# **MAC THOMPSON SITE PLAN**

## **STAFF REPORT #4**

February 9, 2022

**PLAN UNDER REVIEW:** MacThompson Site Plan, 48 Lowell Road, Hudson, New Hampshire 03051, Tax Map 190 Lot 191, Hudson, New Hampshire; prepared by Benchmark LLC, 1F Commons Drive, Suite 35, Londonderry, New Hampshire 03053; prepared for owner MacThompson Realty, Inc., 3 Marmon Drive, Nashua, New Hampshire 03060; consisting of 12 sheets with General Notes 1-36 on Sheet 3; dated August 3, 2021, last revised January 21, 2022.

SCALE: 1"=20' SHEET 4 OF 12 AUGUST 3, 2021

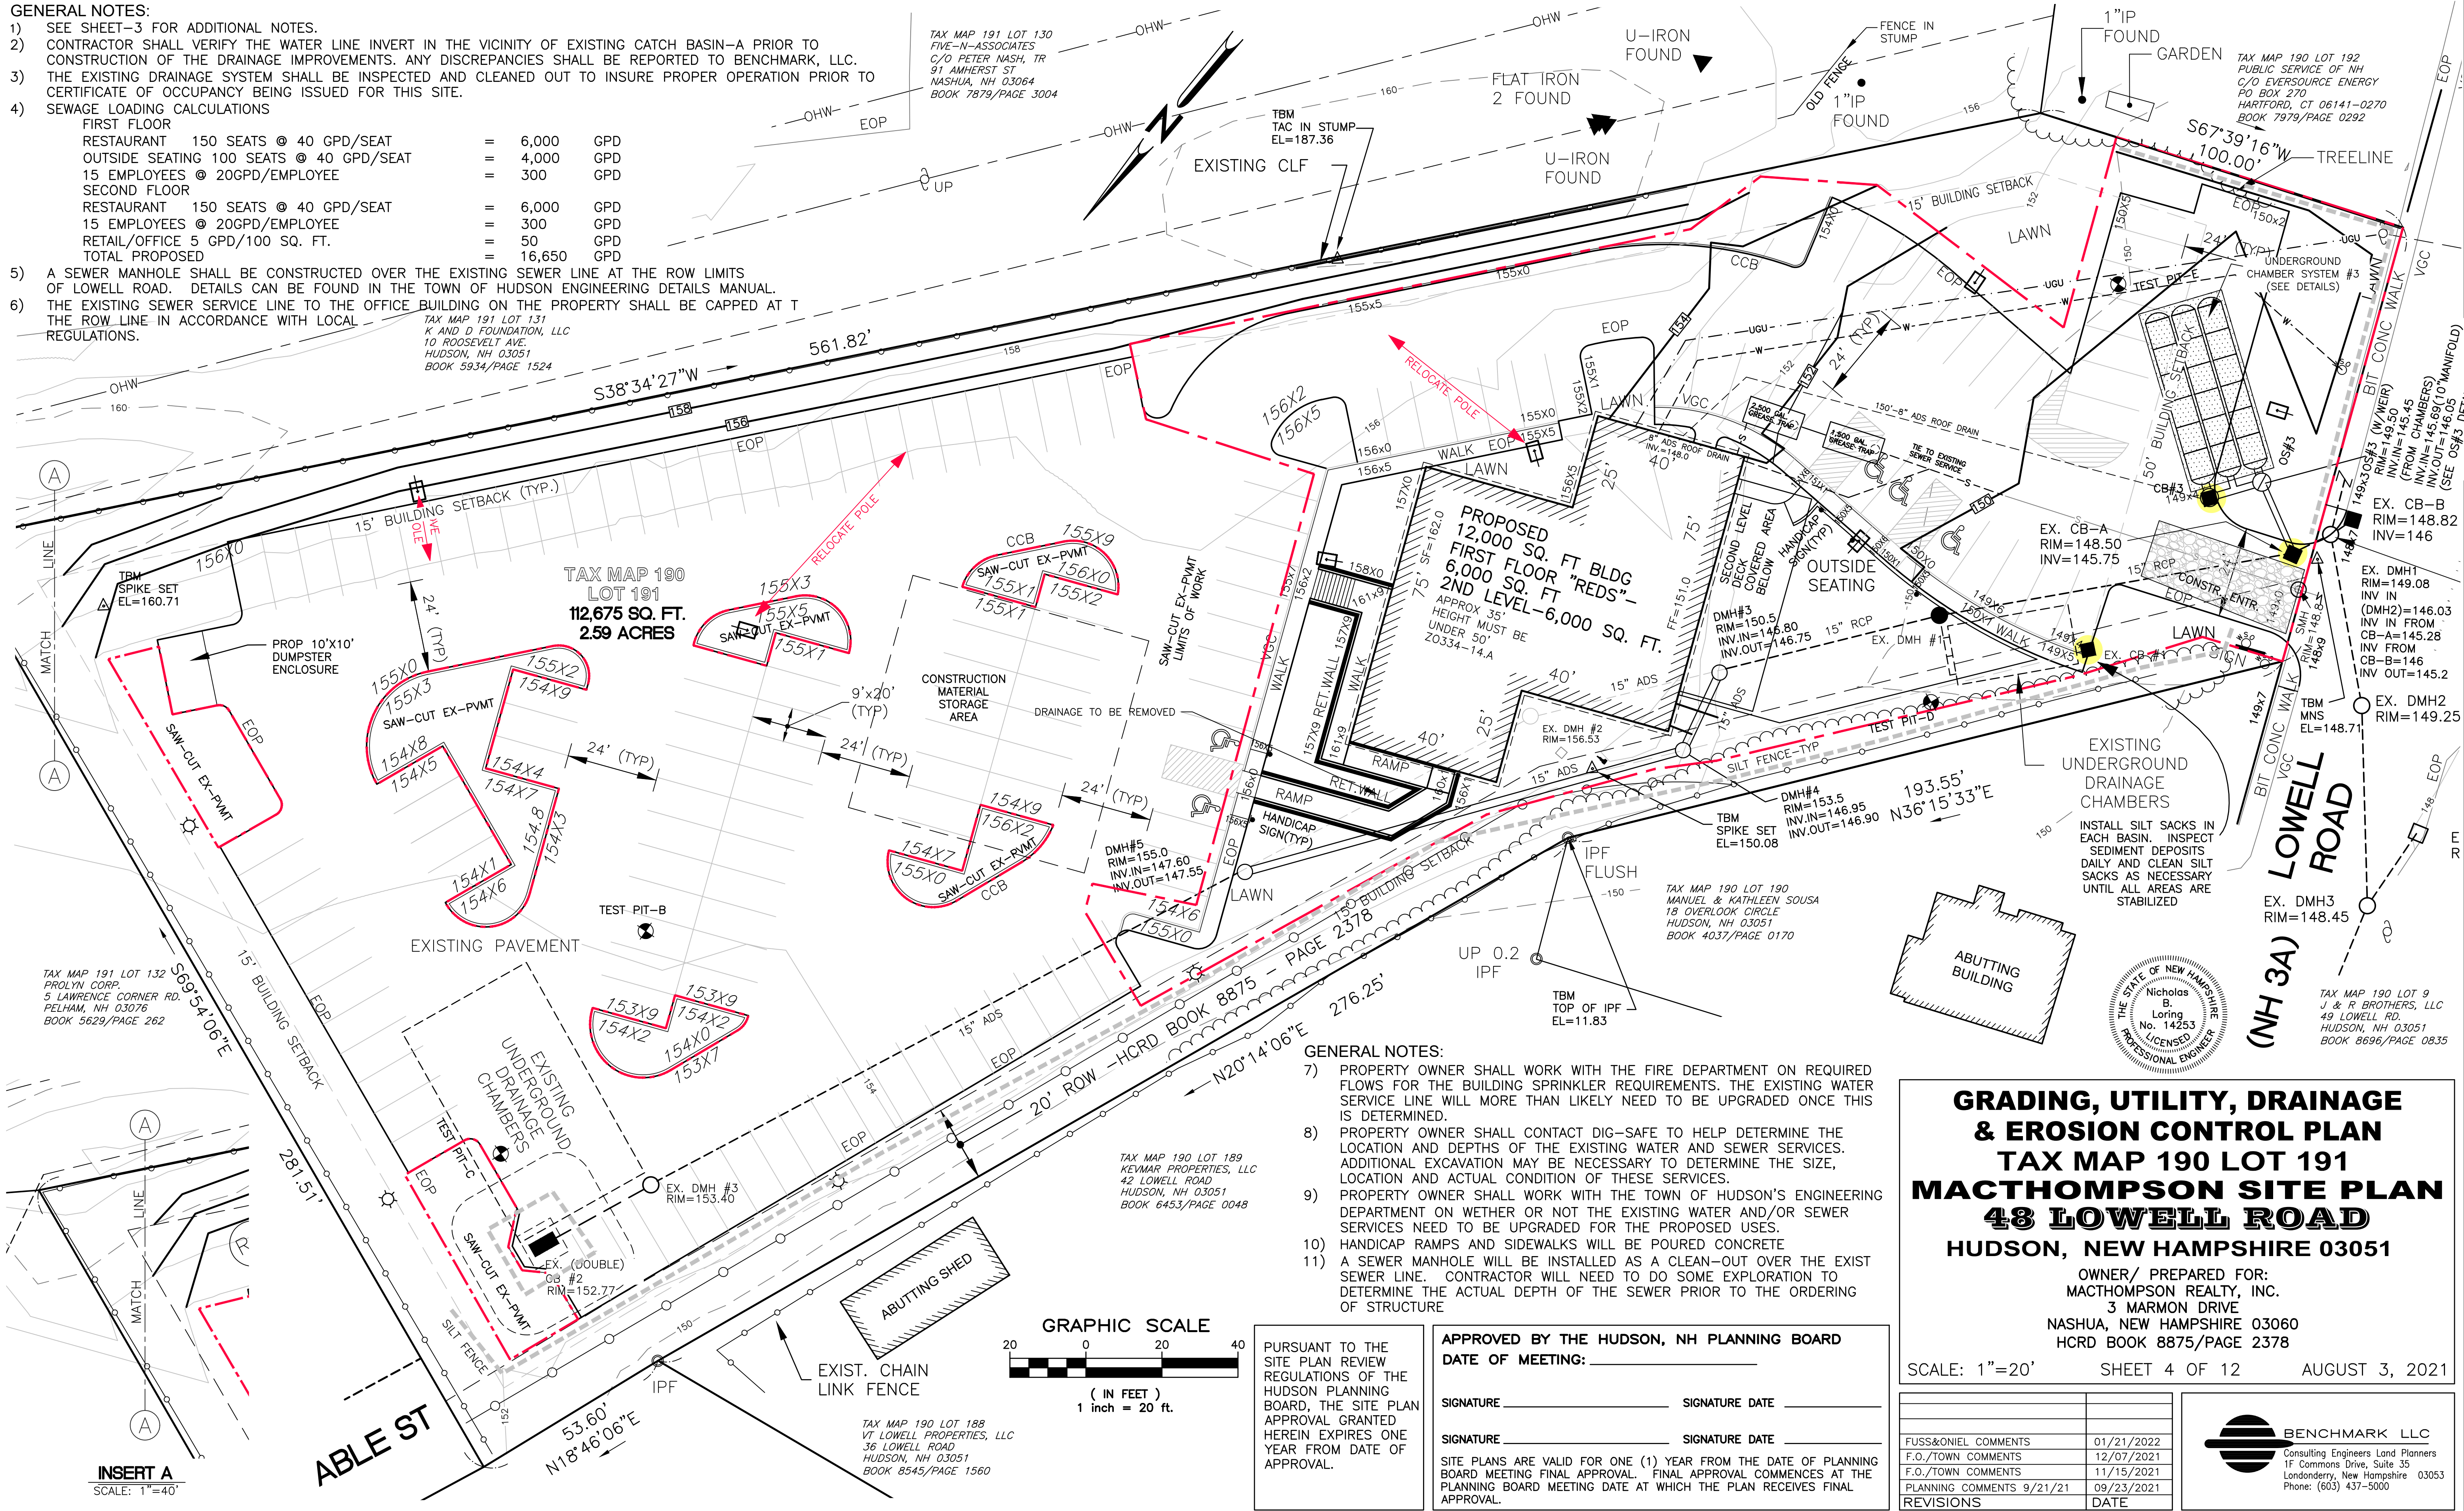
**Current Fuss & O'Neill Comment:** The applicant has revised the cleanout to a sewer manhole per the Town recommendation. We note that no elevations for the rim, invert in or invert out were provided.

**Current Fuss & O'Neill Comment:** The applicant has added test pit B on Plan Sheet 4 and provided test pit logs upon Plan Sheet 2. We note that it is common engineering practice as well as a NHDES requirement that test pits performed be located within the footprint of the proposed underground chamber system. The applicant should provide test pit data for a test pit performed within the footprint of the proposed system, or discuss with the Town to ensure the location of the test pit is adequate for the current drainage application.

**Current Fuss & O'Neill Comment:** The applicant has added test pit B on Plan Sheet 4 and provided test pit logs upon Plan Sheet 2. We note that it is common engineering practice as well as a NHDES requirement that test pits performed be located within the footprint of the proposed underground chamber system. The applicant should provide test pit data for a test pit performed within the footprint of the proposed system, or discuss with the Town to ensure the location of the test pit is adequate for the current drainage application.

**Per our previous submittal we do not have clear information on the depth of the sewer. For the plans we have added a note indicating that some exploration will need to be done prior to the ordering of this structure (note 11, sheet 4)**

SCALE: 1"=30' SHEET 5 OF 12 AUGUST 3, 2021

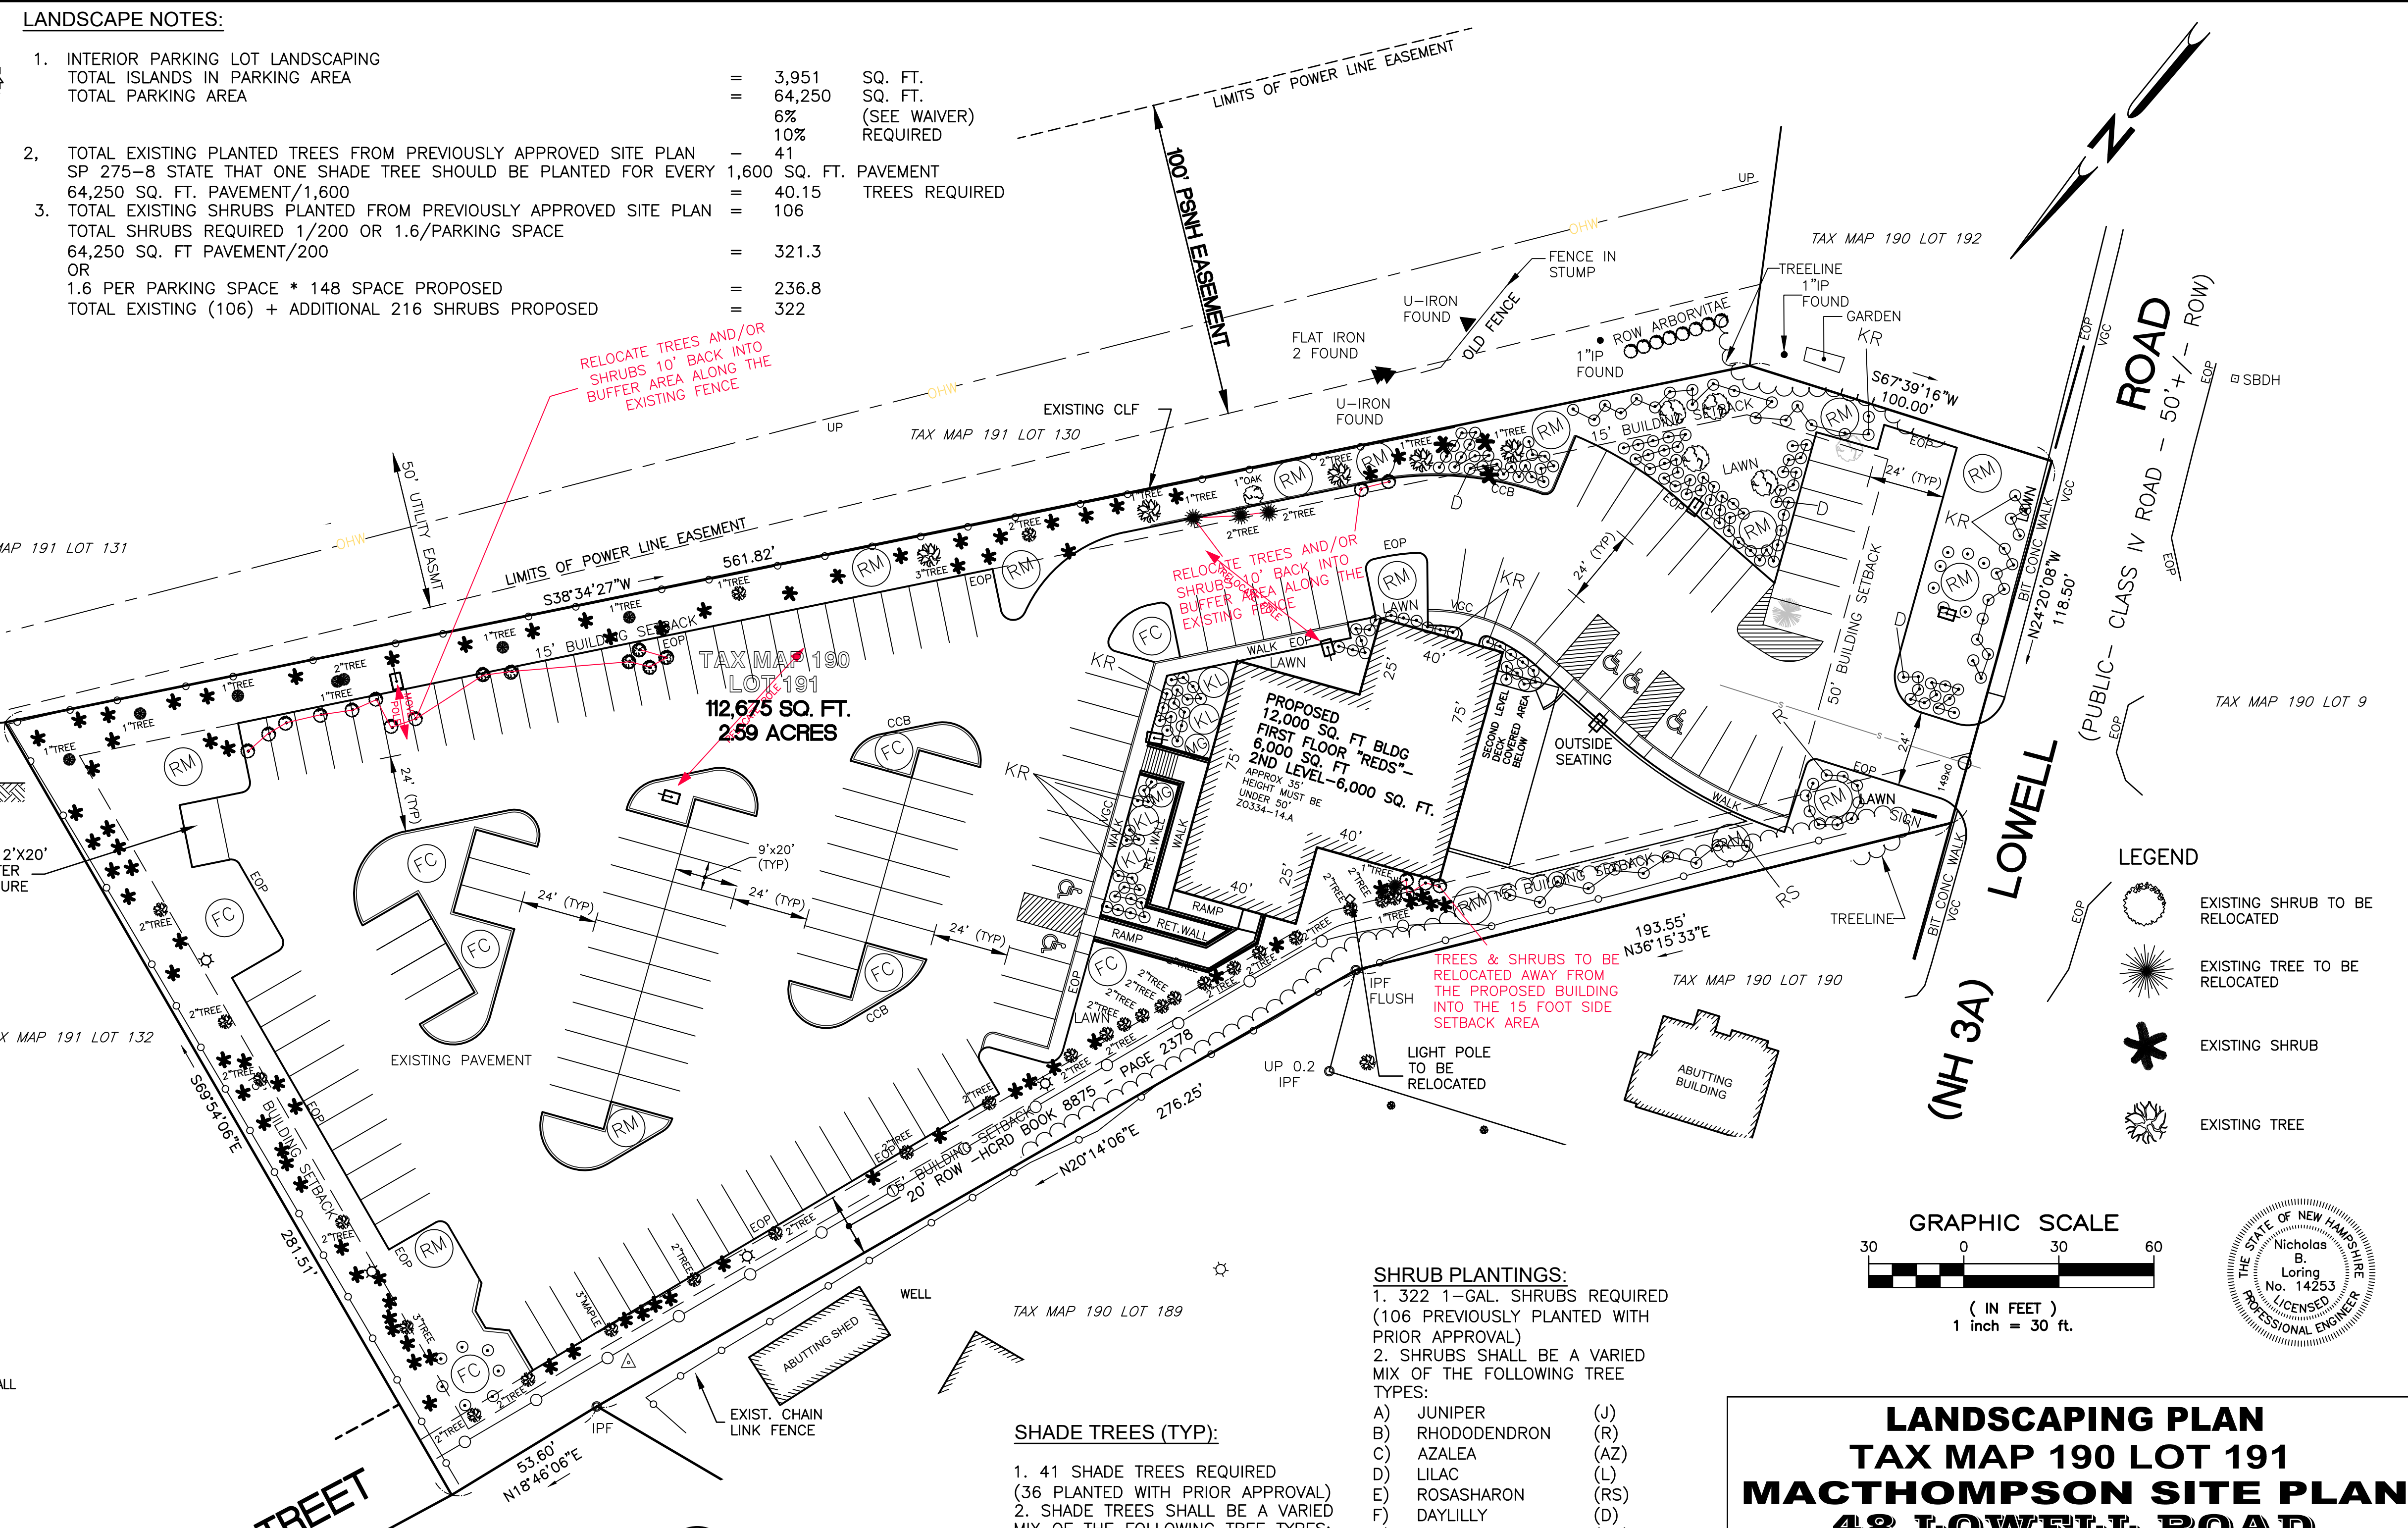
3. **Parking Lot Landscaping Requirements [§ 275-8.C(7)]:** The Applicant had indicated that, despite not meeting the landscaping area requirement (which was waived), the required planting will be met. Sheet 5 of the revised plan shows the calculation of the required planting.

- a. Landscape Note #2 states 41 trees were planted as part of previously approved site plan, while Shade Trees Note #1 states 36 were planted. Since this is a new site plan, the Applicant may consider rephrasing the wording to indicate:

- i. The number of tree/shrub required for the current site plan;
  - ii. The number of existing tree/shrub to remain or relocated on-site; and
  - iii. The number of new tree/shrub planting proposed to satisfy the requirements.

- b. Staff has previously noted concern over the parking lot shrub requirement being so high, that it leads to overcrowding of shrubs. It is Staff’s understanding that the Applicant has worked with a Landscape Architect to achieve their preferred landscape treatment, therefore these concerns are mitigated. It is possible, as in any site plan, that upon installation, minor modifications to the landscape plan may be necessary for plant health.

**WATER SERVICE DETAIL (NO SCALE)**

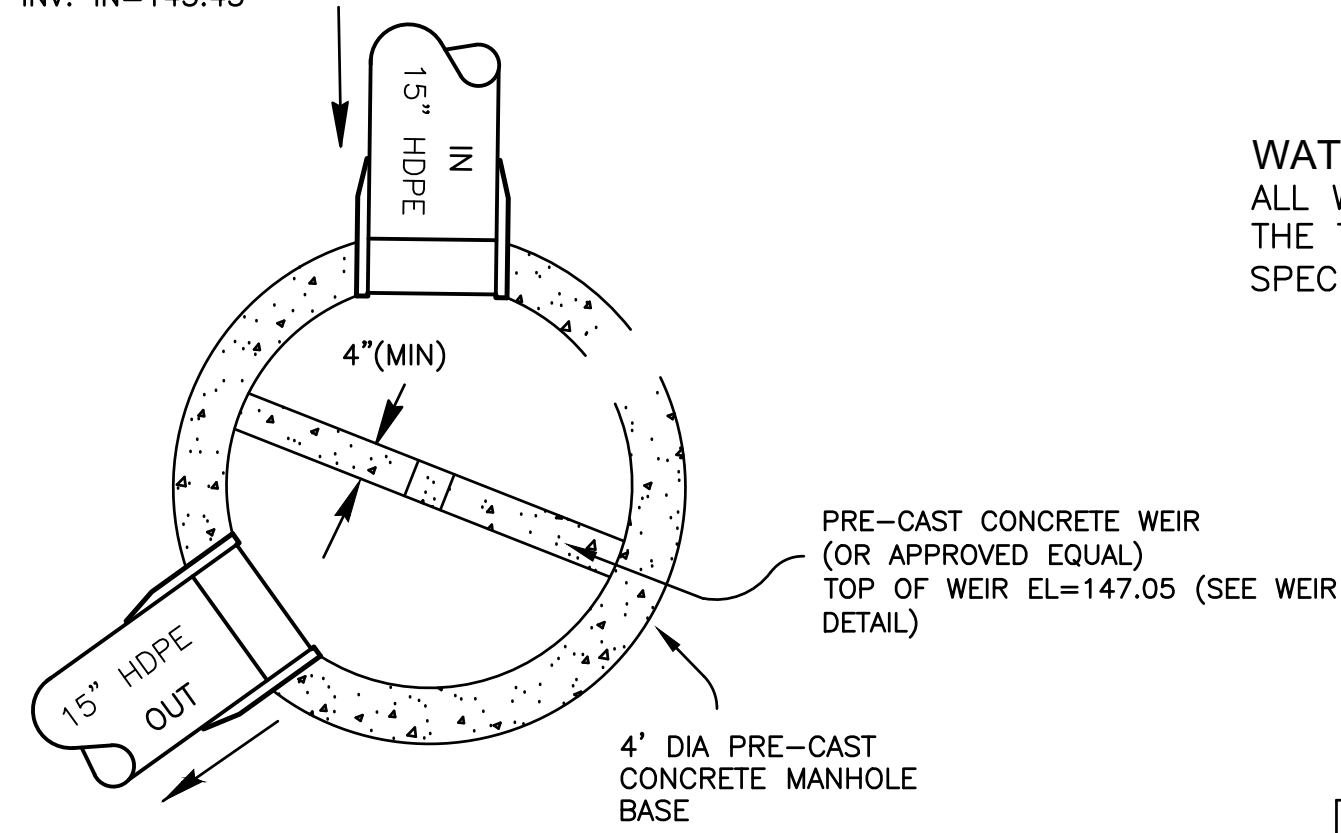
**Current Fuss & O'Neill Comment:** The applicant has stated that the details were cleaned up. We note if the pipe detail on Sheet 8 is for a water service, then it should be labeled as such. Both water details are located on a sheet titled Drainage Details and one is not labeled.

**Current Fuss & O'Neill Comment:** The applicant has stated that the details were cleaned up. We note if the pipe detail on Sheet 8 is for a water service, then it should be labeled as such. Both water details are located on a sheet titled Drainage Details and one is not labeled.

We have changed the title of sheet 8 to "Construction Details". The water service Detail has also been labeled
